ADDENDUM NO. 1

PROJECT NAME: Legacy High School BB - SB Renovations

CLIENT NAME: Mansfield ISD

ADDENDUM DATE: Tuesday, April 29, 2025

MASTER FLOOR PLAN -SOFTBALL

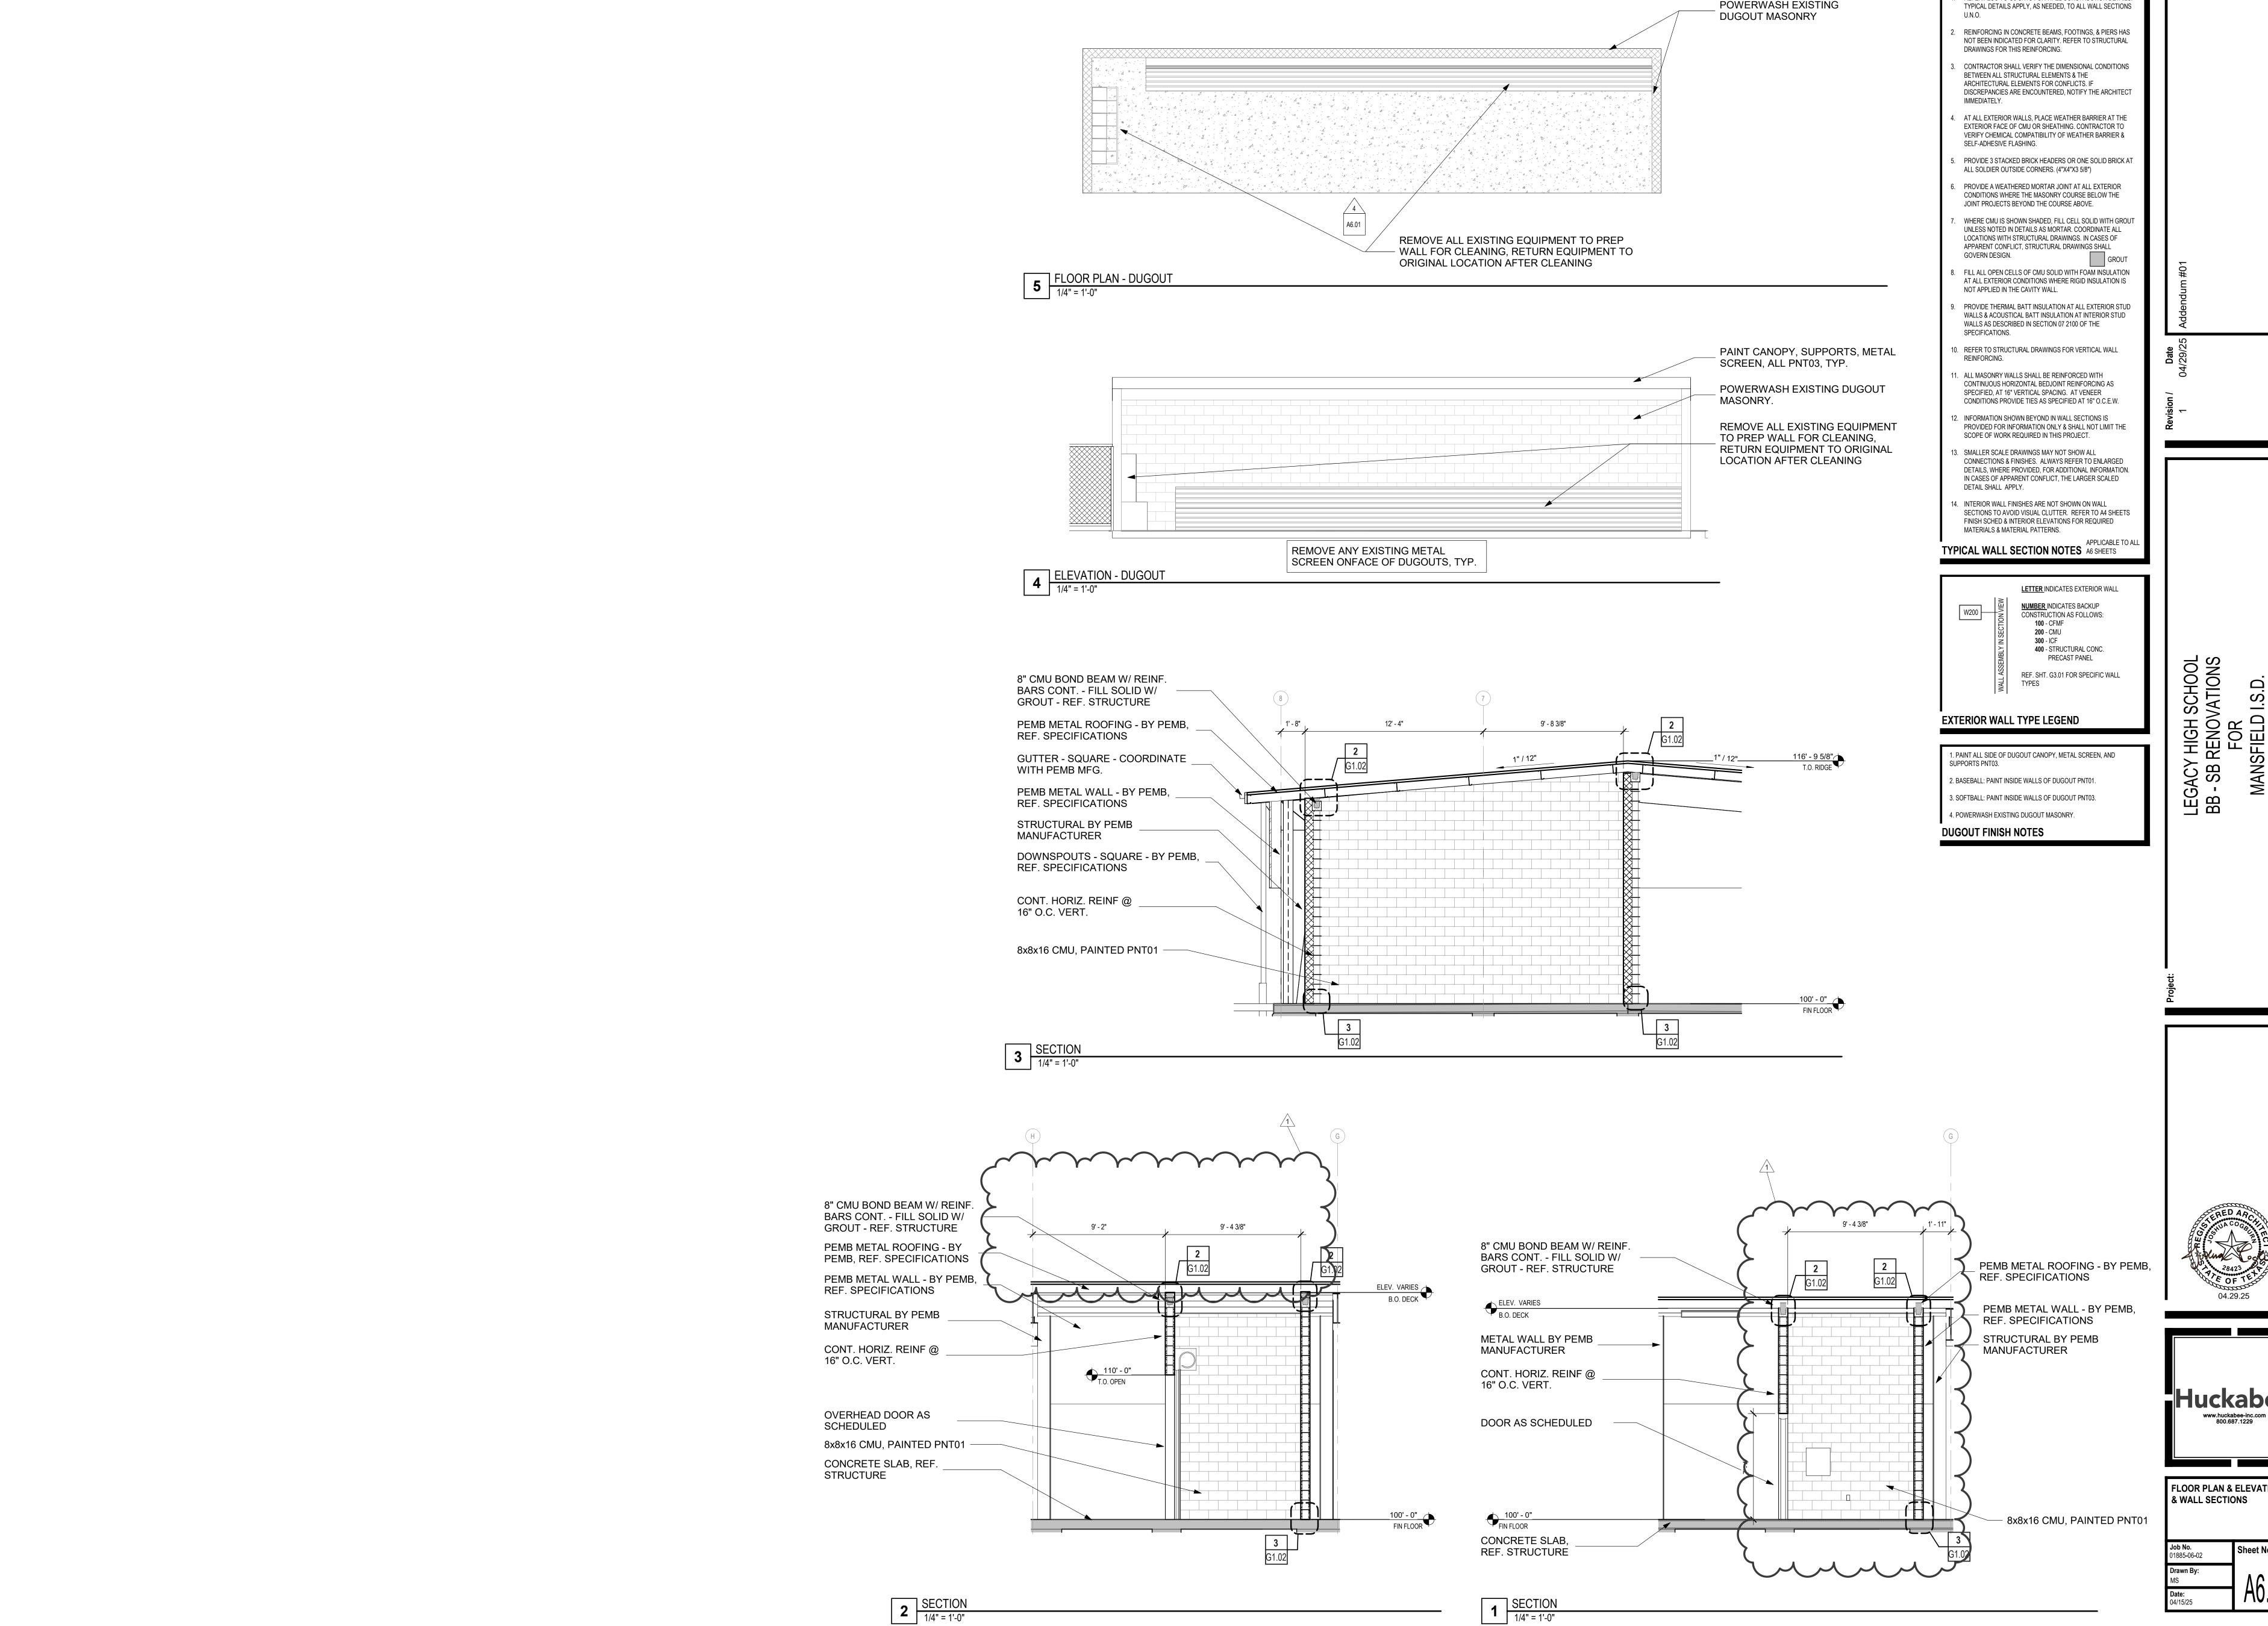
AD No 1, Arch. Item 5: To the Drawings, Sheet A1.02, "FLOOR PLAN - SOFTBALL BATTING CAGES,"

1) Moved the Baseball Storage to sit over structural footings. Refer to attached drawing A1.02
